Relevant Information for Local Planning Panel

SUBJECT: Information Relevant To Item 3 – Development Application: 21C Billyard Avenue, Elizabeth Bay – D/2023/727

**SUPPLEMENTARY JOINT EXPERT REPORT ADDRESSING HEIGHT OF BUILDINGS
CALCULATION**

Supplementary Joint Expert Report
Appendix B: Height Plane Amendment

Onslow Ave

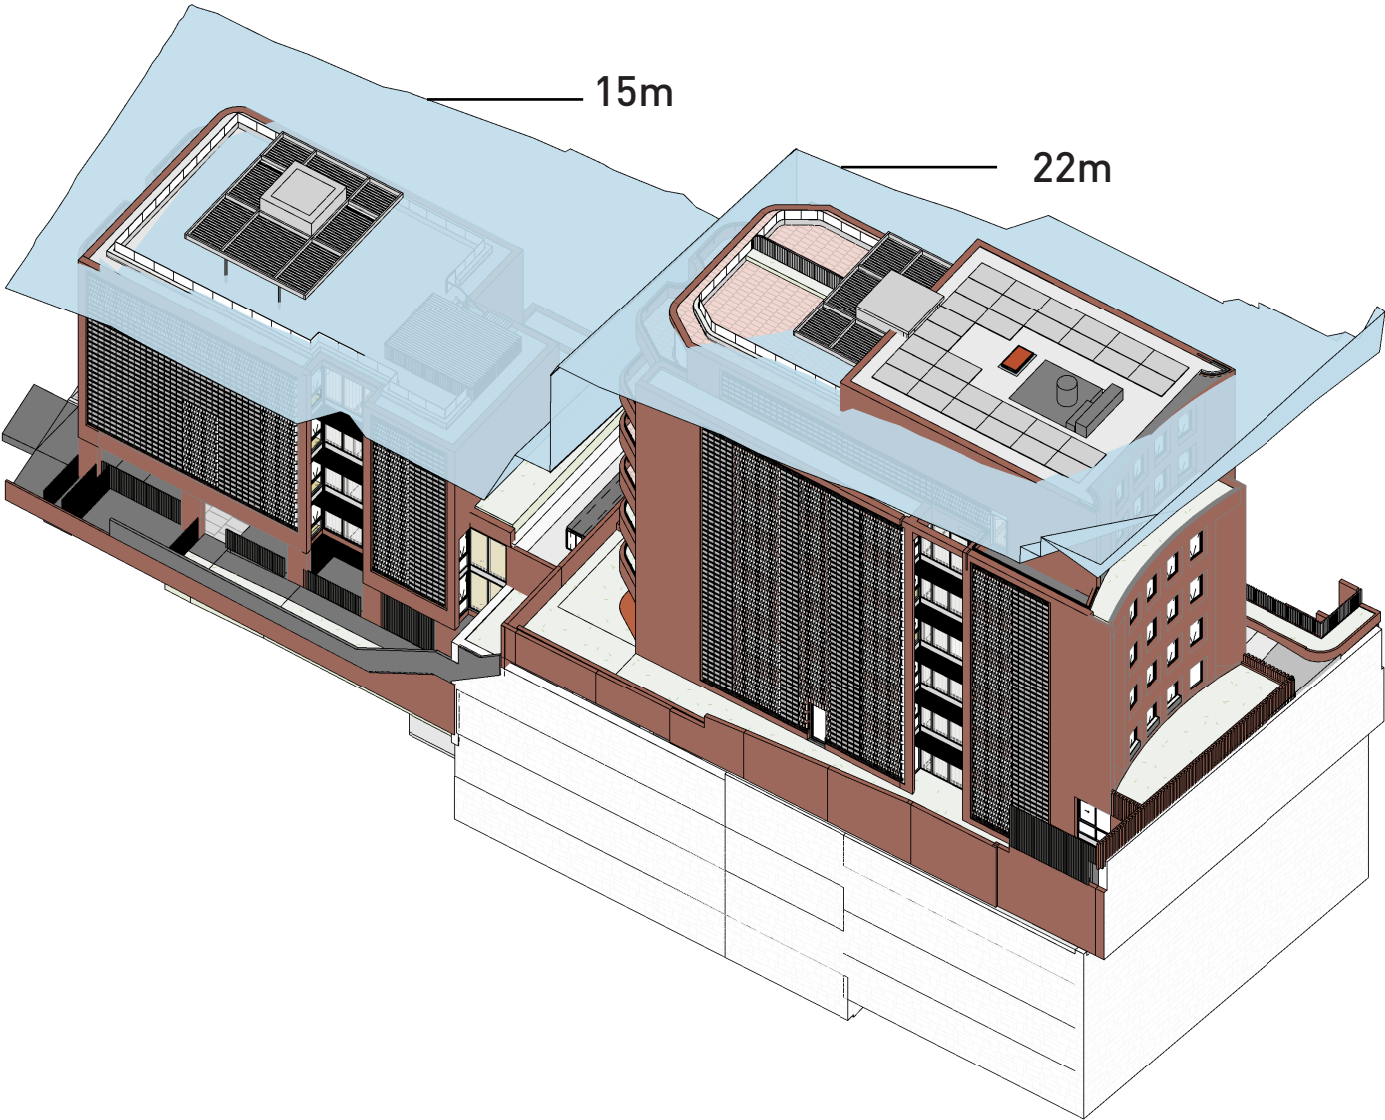
Current: DA Issue 09

Amended

Bettar Height Plane - Additional Exceedance

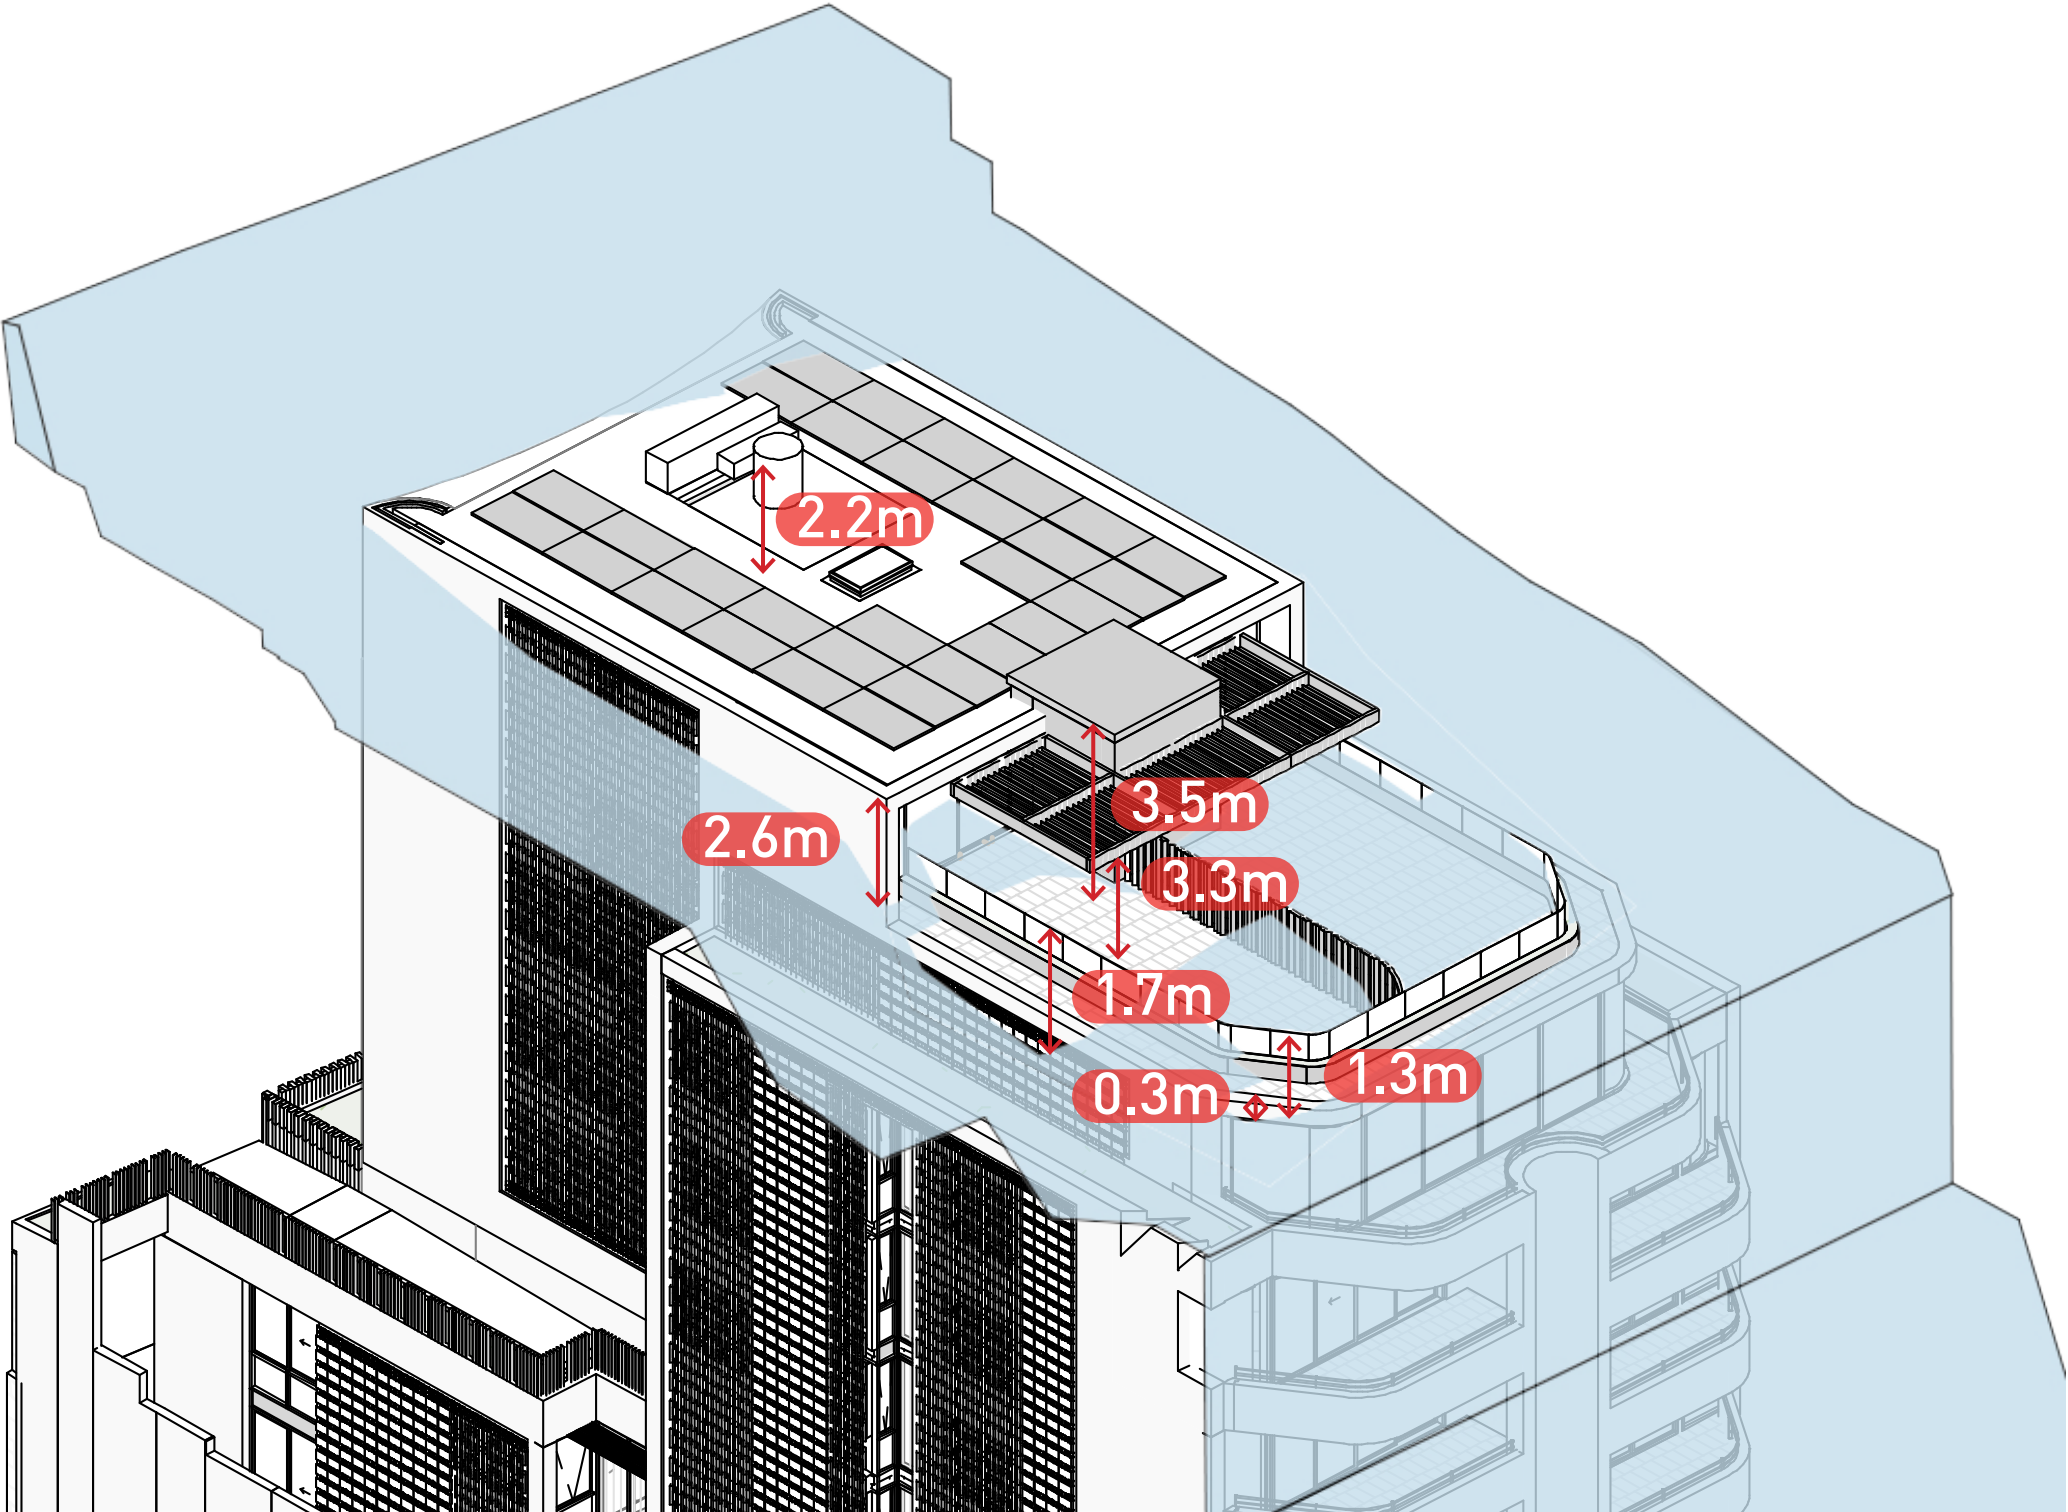
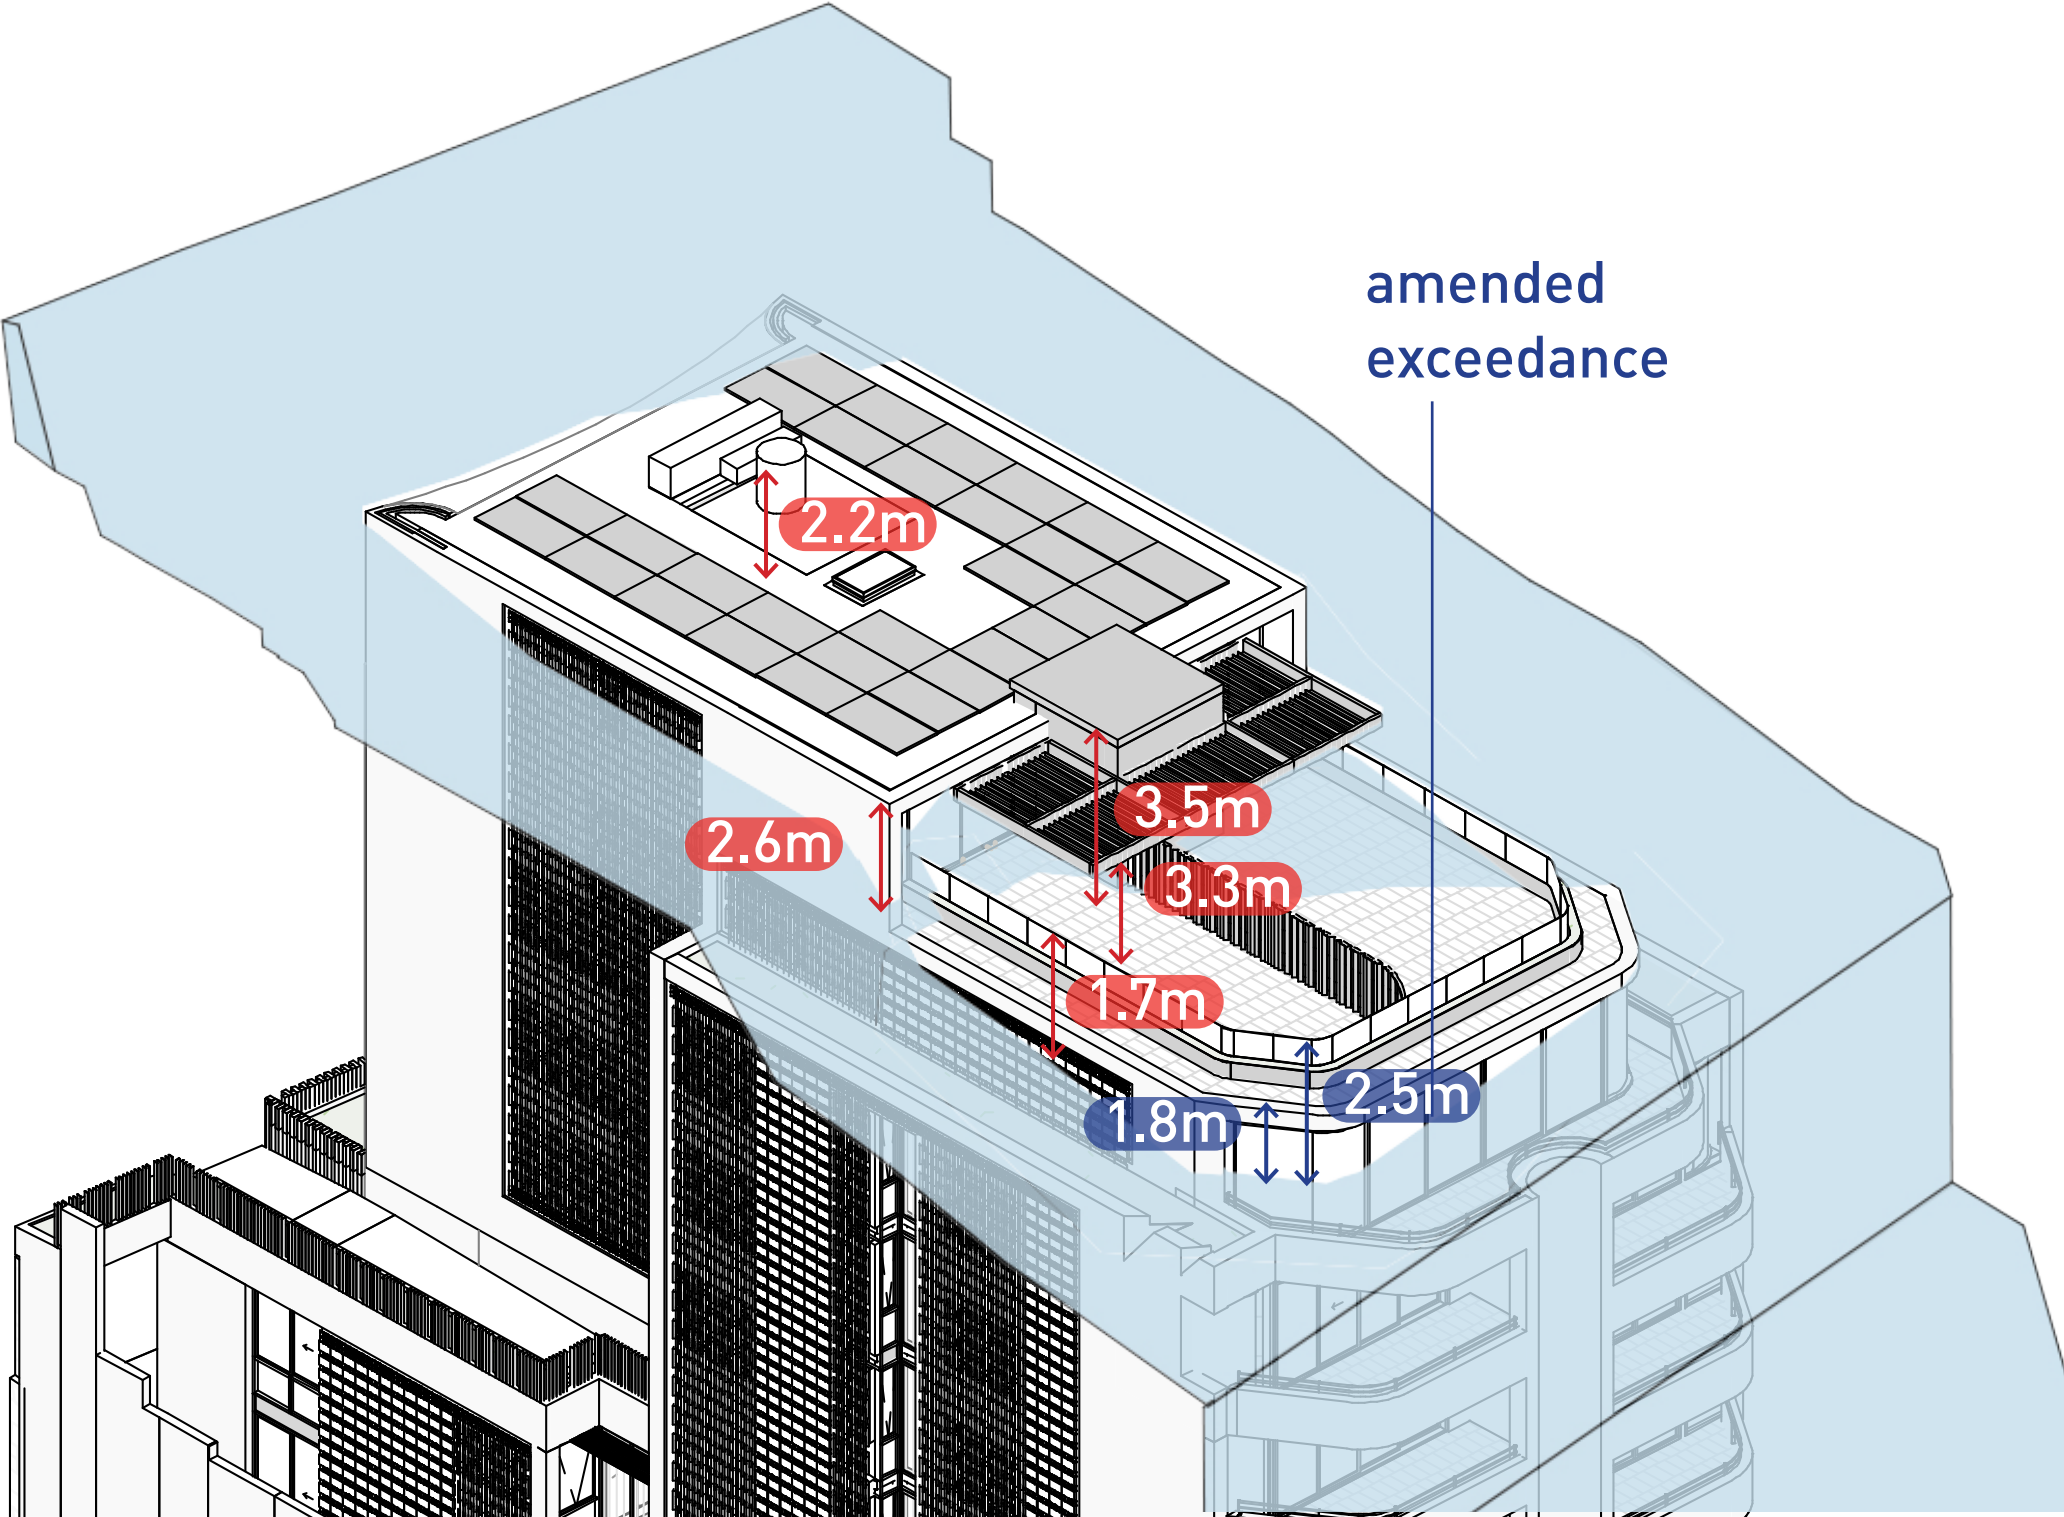
Whilst the building envelope and form has not changed in this amendment, the proportion of the building that exceeds the newly established LEP height limit has increased in the north-eastern corner of the Onslow Avenue building.
